To: Holders of Service Bulletin 130406-21-A4011

This page transmits Revision 3 to cabin air pressure outflow/safety valve Service Bulletin 130406-21-A4011, dated Sep 28/94.

ALERT SERVICE BULLETIN

AIR CONDITIONING -- Outflow/Safety Valve -- Identification of valves that require replacement

Outflow/Safety Valve Identification Plate
Figure 1

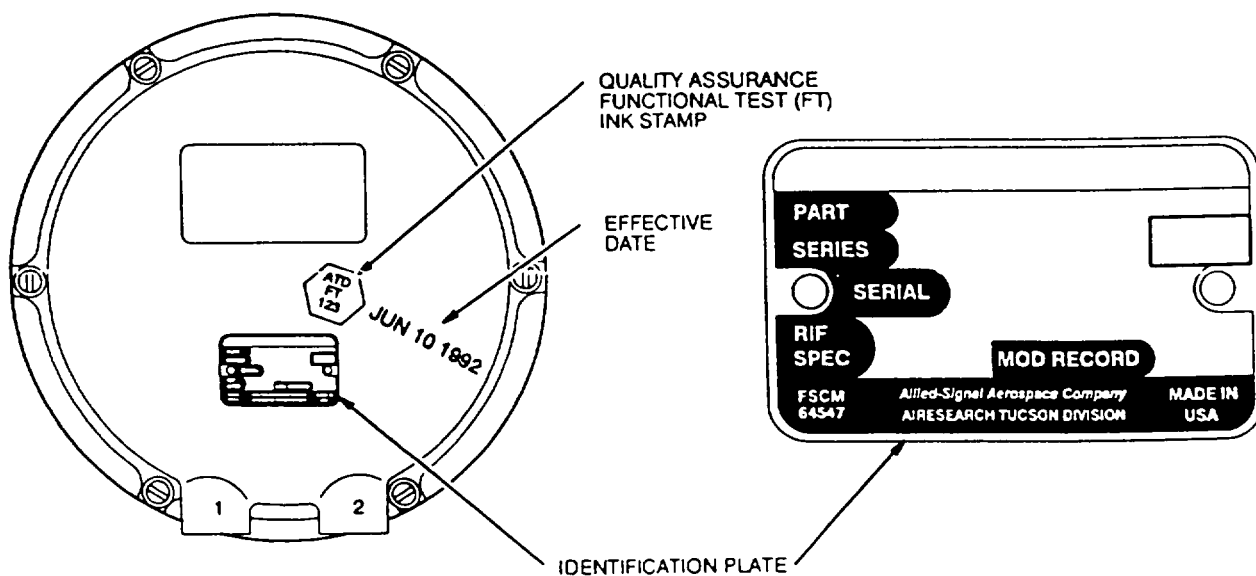
- A. Visually check the valve serial number appearing on the identification plate against the effectivity list. (See figure 1.) If the serial number of the valve appears on the effectivity list, replace valve in accordance with aircraft manufacturers instructions, unless one of the following conditions is satisfied.
- B. If the serial number of the valve appears on the effectivity list, but the identification plate MOD RECORD block contains "PCA," no further action is required and the valve is considered serviceable.
- C. If the serial number of the valve appears on the effectivity list, but the valve cover has an inked ATD Quality Assurance "Functional Test (FT)" stamp dated June 1992, or later, no further action is required and the valve is considered serviceable. (See figure 1.)
- D. Reidentification

Outflow/Safety Valve Identification Plate
Figure 1

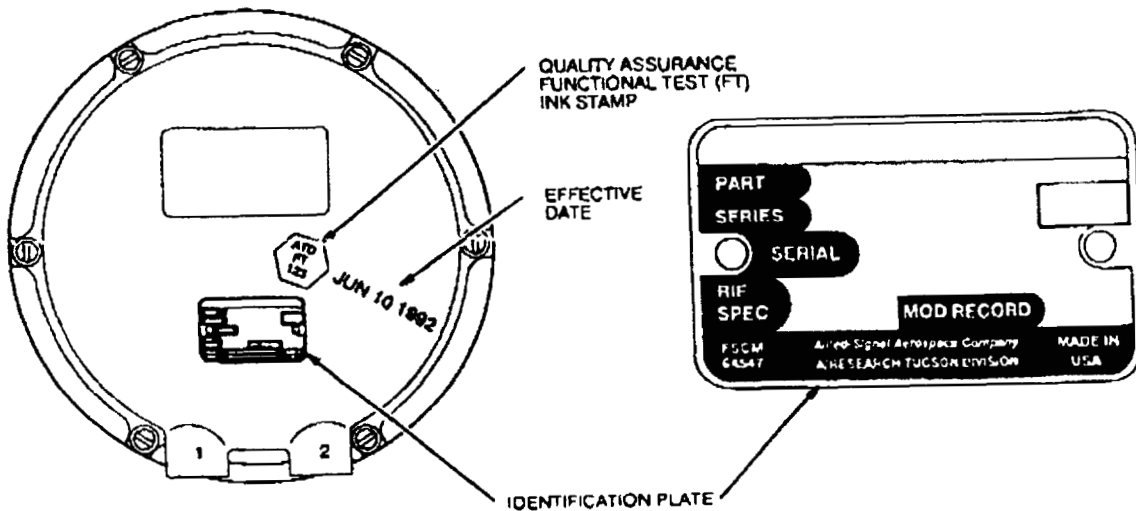
- A. Visually check the valve serial number appearing on the identification plate against the effectivity list. (See figure 1.) If the serial number of the valve appears on the effectivity list, replace valve in accordance with aircraft manufacturers instructions, unless one of the following conditions is satisfied.
- B. If the serial number of the valve appears on the effectivity list, but the identification plate MOD RECORD block contains "PCA," no further action is required and the valve is considered serviceable.
- C. If the serial number of the valve appears on the effectivity list, but the valve cover has an inked ATD Quality Assurance "Functional Test (FT)" stamp dated June 1992, or later, no further action is required and the valve is considered serviceable. (See figure 1.)
- D. Reidentification
